January 18, 2010

RE: ADDITIONAL INFORMATION REQUESTED FOR THE MOORE RANCH IN  
SITU URANIUM RECOVERY PROJECT LICENSE APPLICATION (TAC  
JU011), SAFETY EVALUATION REPORT OPEN ISSUES.

**Hydrology Open Issue No. 17**  
**Restoration of groundwater to the standards in 10 CFR part 40, Appendix A,**  
**criterion 5B is not proposed**  
**May 11 2009 Teleconference**

Figure 1. The Location of Air Monitoring Stations for the Moore Ranch Site.

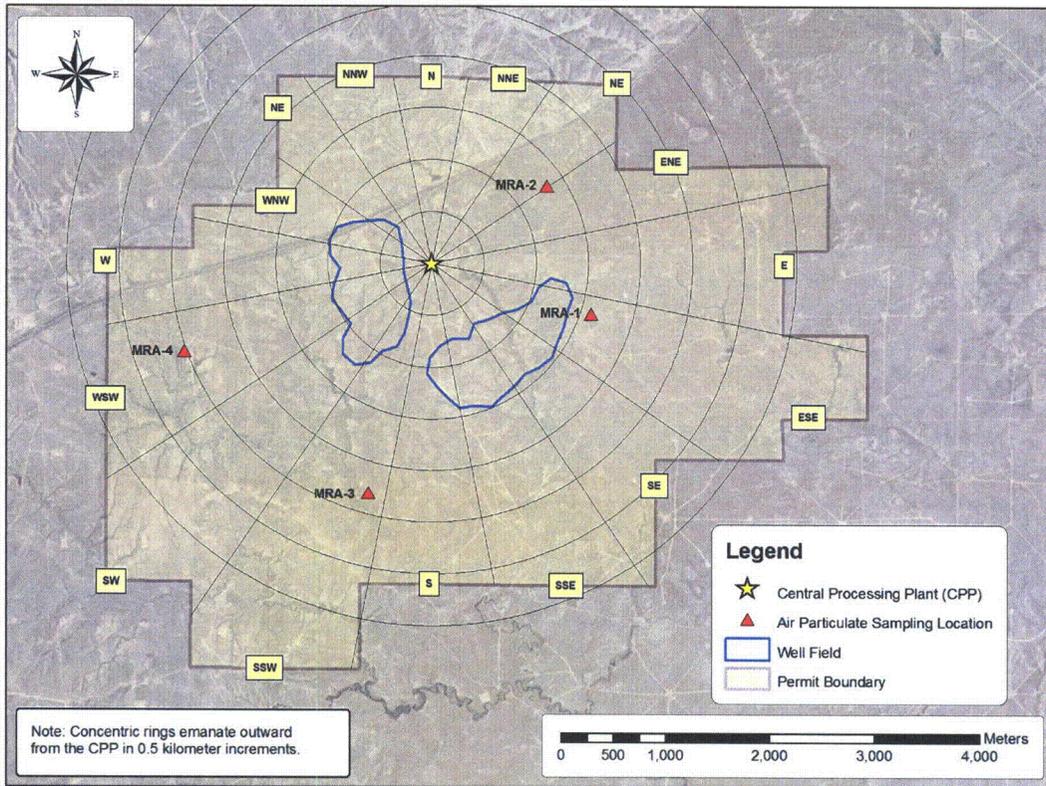
The applicant shows the air particulate and radon sampling locations in Figure 5.7-2, however, the applicant does not identify these air particulate and radon sampling locations by sector or distance. The applicant has not provided sufficient information demonstrating that the three site boundary air particulate and radon sampling stations have been placed in locations and sectors that have the highest predicted concentrations of airborne particulate that is consistent with Regulatory Guide 4.14. The staff notes that the location of the air particulate and radon sampling locations may have an impact on the proposed soil sampling locations.

Figure 1 below shows the air monitoring locations, the sector with respect to the central processing plant, and the distance from the central processing plant. The predominant wind direction as discussed in Section 2.5.2.4 of the Technical Report is from the southwest to west sectors and is from these sectors 40% of the time.

MRA-1 is approximately 1.5 kilometers from the central processing plant in the east-southeast sector. This location is well positioned to monitoring potential airborne emissions from the site carried by winds from the west.

MRA-2 is approximately 1.3 kilometers from the central processing plant bordering the northeast and east-northeast sector. This location is well positioned to monitor potential airborne emissions from the site carried by winds from the southwest.

MRA-3 is approximately 2.4 kilometers from the central processing plant in the south-southwest sector. This location is well positioned to monitoring potential airborne emissions from the site carried by winds from the north and north-northeast sectors.

MRA-4 is approximately 2.5 kilometers from the central processing plant in the west-southwest sector. This location is well positioned to monitor background conditions since the predominant winds are from the southwest to west sectors.

Figure A4.1-2. Model Domain, Wellfield Spill Simulation  
Moore Ranch Uranium Project, Wyoming

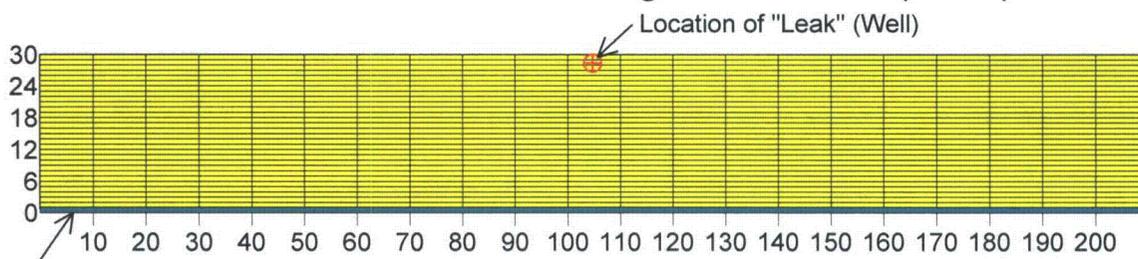
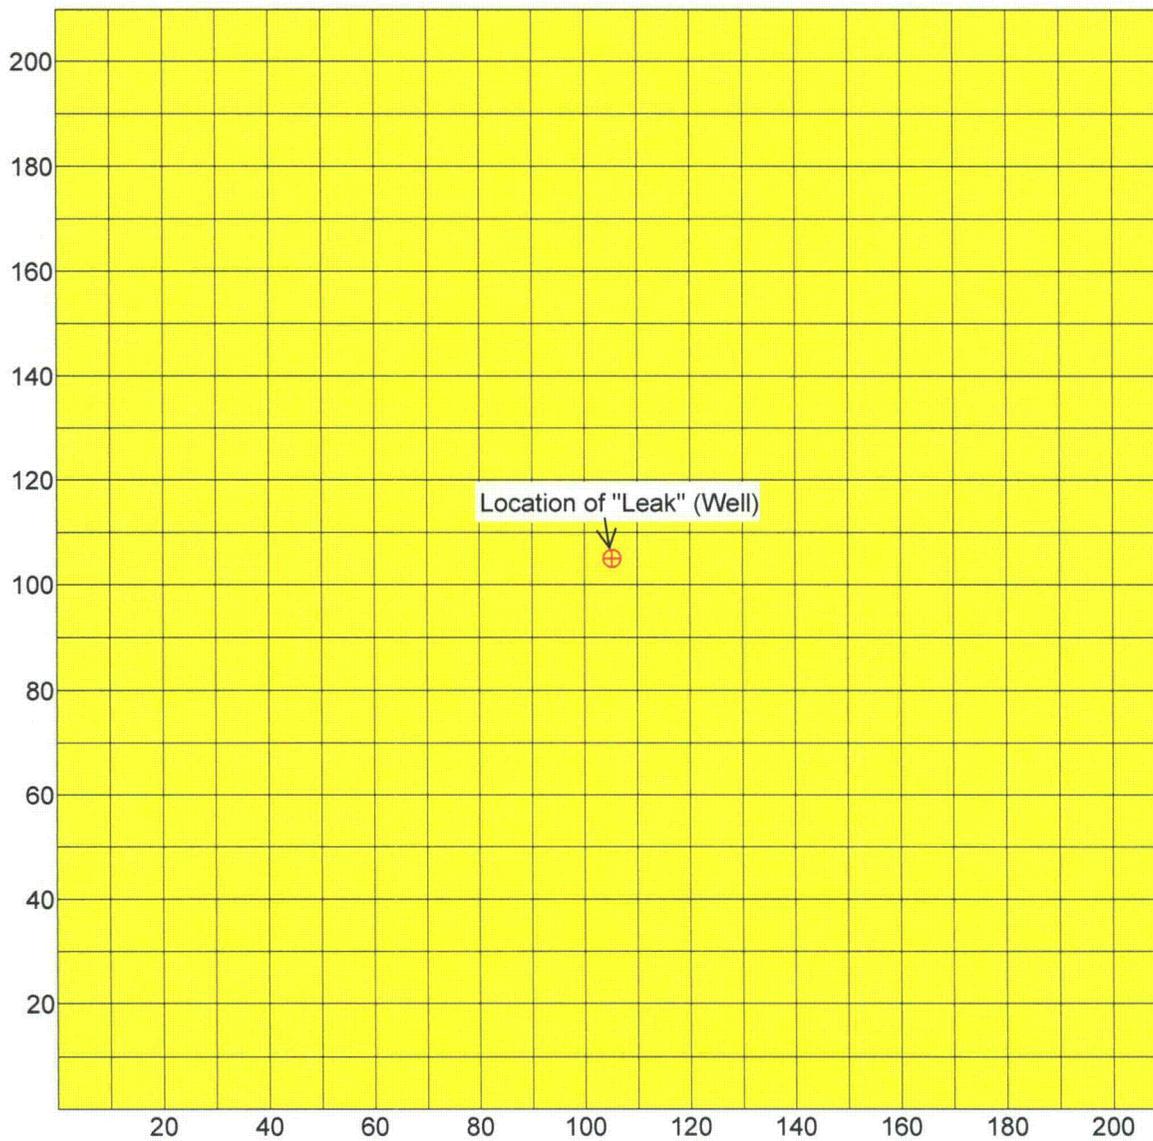
The model was setup with 30 layers. The thickness of each layer was set to 1 foot. The model domain included 21 columns and 21 rows, with each cell having dimensions of 10 ft by 10 ft. The lowermost layer in the model represents the water table. This boundary was modeled using the general head boundary condition of MODFLOW with a head of 0 feet. The sides of the model were simulated as no flow boundaries. The model domain was set large enough so that the "box" would not be filled during the duration of the simulation. The model domain is illustrated in Figure 4.4.2.3.2b

The model was setup with 30 layers. The thickness of each layer was set to 1 foot. The model domain included 21 columns and 21 rows, with each cell having dimensions of 10 ft by 10 ft. The lowermost layer in the model represents the water table. This boundary was modeled using the general head boundary condition of MODFLOW with a head of 0 feet. The sides of the model were simulated as no flow boundaries. The model domain was set large enough so that the "box" would not be filled during the duration of the simulation. The model domain is illustrated in Figure A4.1-2.

| <b>Figure A4.1-3. Hydraulic Head at Observation Point 29<br/>Low-Volume, Long-Duration Simulation<br/>Moore Ranch Uranium Project, Wyoming</b> |   |

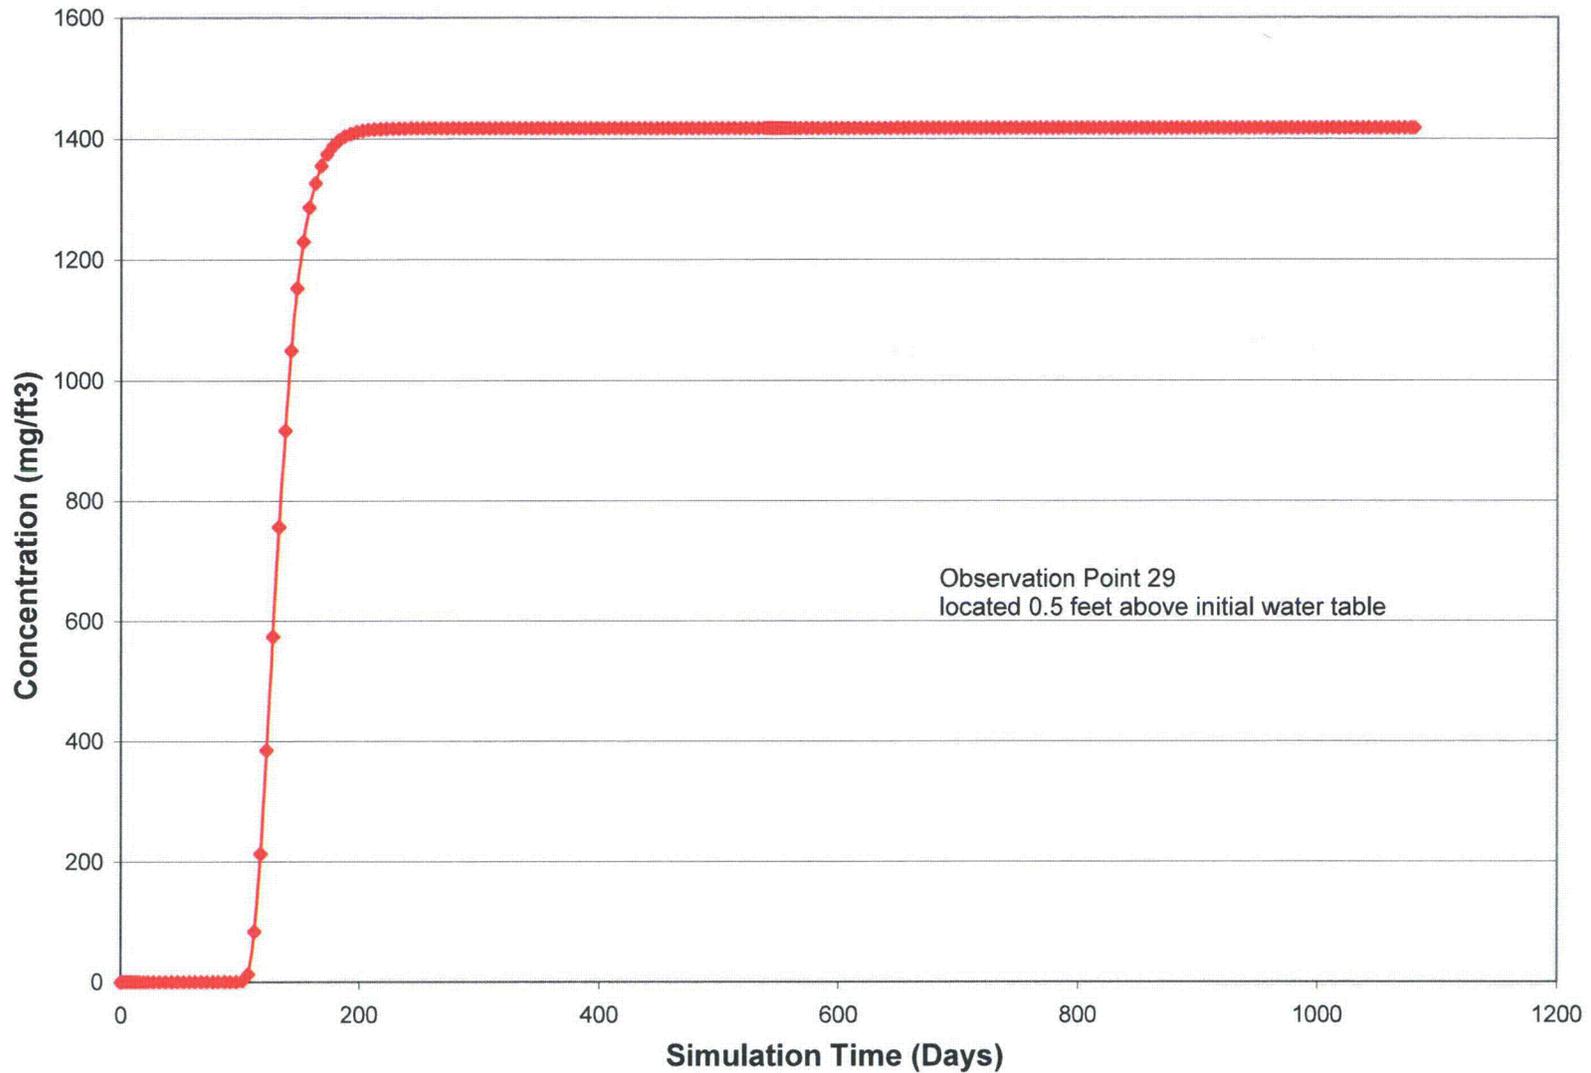
layers 14 and 29. The observation point in layer 29 represents the position just above the water table at the start of the simulation. Results of the simulation indicate that the arrival of the wetting front at the water table occurs in slightly over 30 days but it takes over 200 days for a fully saturated column to develop from the “leak” down to the water table (Figure 4.4.2.3.2c). Once the “leak” is turned off at 540 days, unsaturated conditions are quickly reestablished.

**Figure A4.1-4. Uranium Concentration at Observation Point 29  
 Low-Volume, Long-Duration Simulation  
 Moore Ranch Uranium Project, Wyoming**

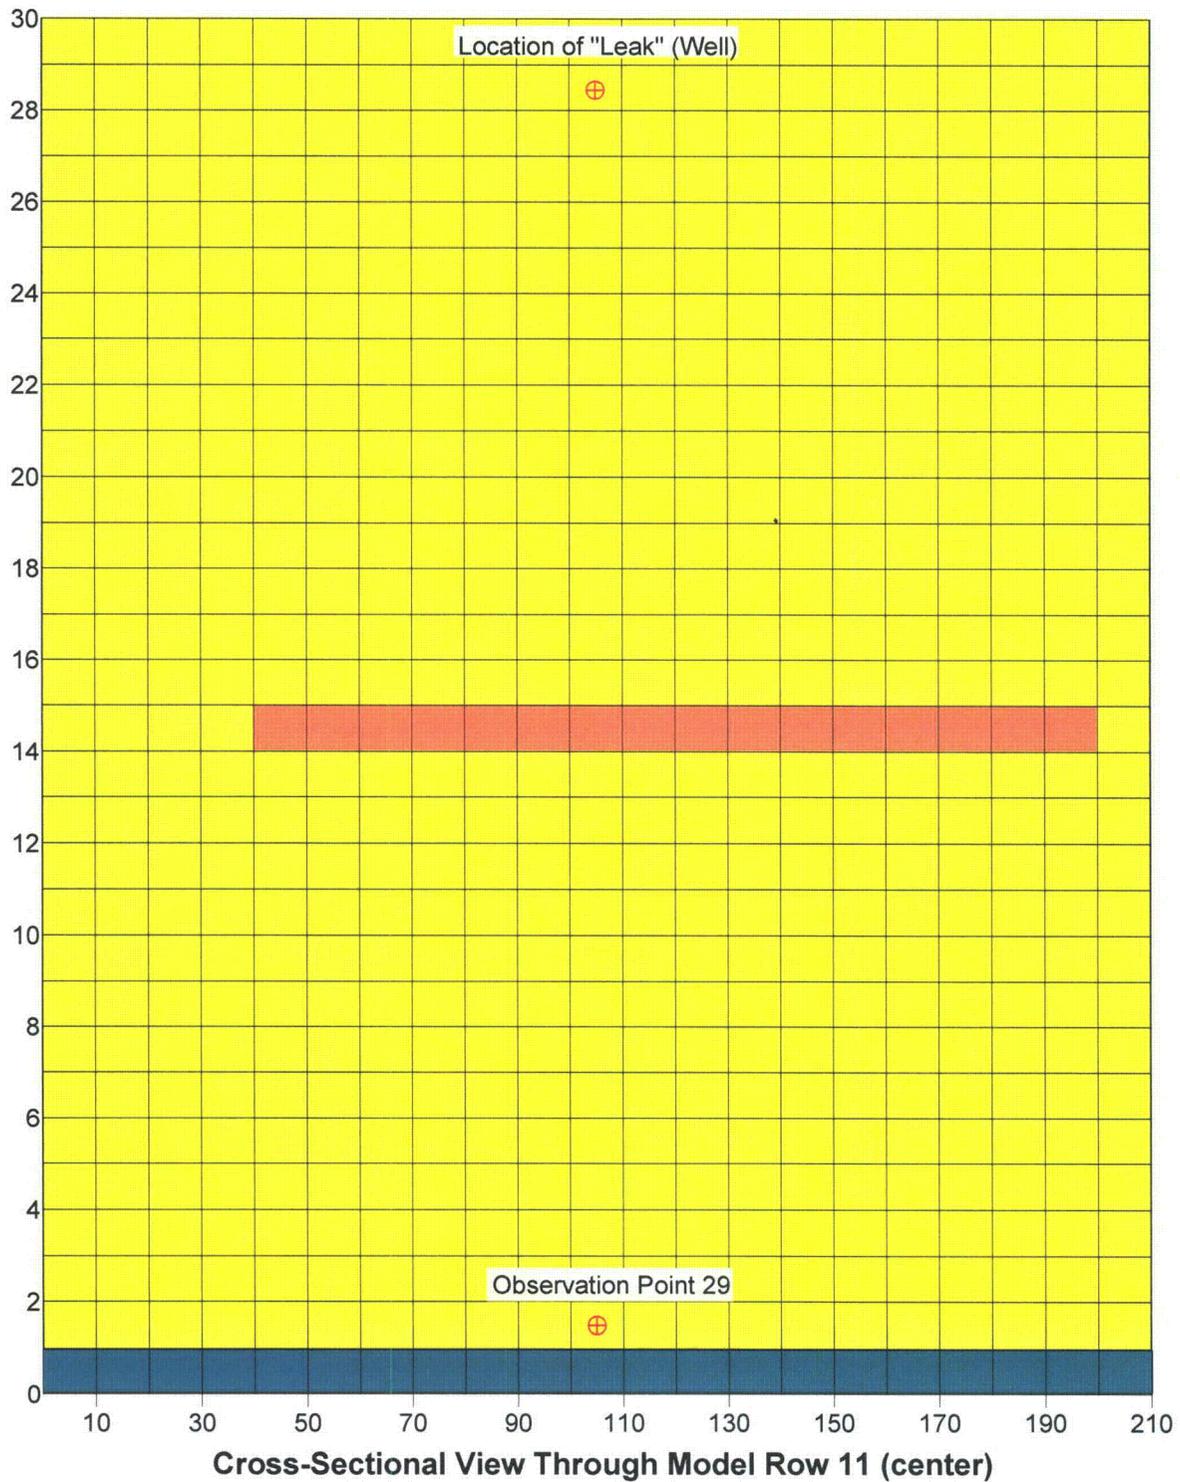
Leakage that exceeds the water quality uranium standard of 0.03 mg/l (0.85 mg/ft<sup>3</sup>) reaches the water table after approximately one hundred days under this idealized, worst case scenario. Figure 4.4.2.3.2d shows the uranium concentration at observation point 29 throughout the simulation. The total mass of uranium that reaches the water table during the 540 day period of operations is on the order of 4.4 kilograms. At the end of the simulation (1080 days), the total mass of uranium that has reached the water table is 5.5E+06 mg or 5.5 kg.

Leakage that exceeds the water quality uranium standard of 0.03 mg/l (0.85 mg/ft<sup>3</sup>) reaches the water table after approximately one hundred days under this idealized, worst case scenario. Figure A4.1-4 shows the uranium concentration at observation point 29 throughout the simulation. The total mass of uranium that reaches the water table during the 540 day period of operations is on the order of 4.4 kilograms (kg). At the end of the simulation (1080 days), the total mass of uranium that has reached the water table is 5.5E+06 milligrams (mg) (5.5 kg).
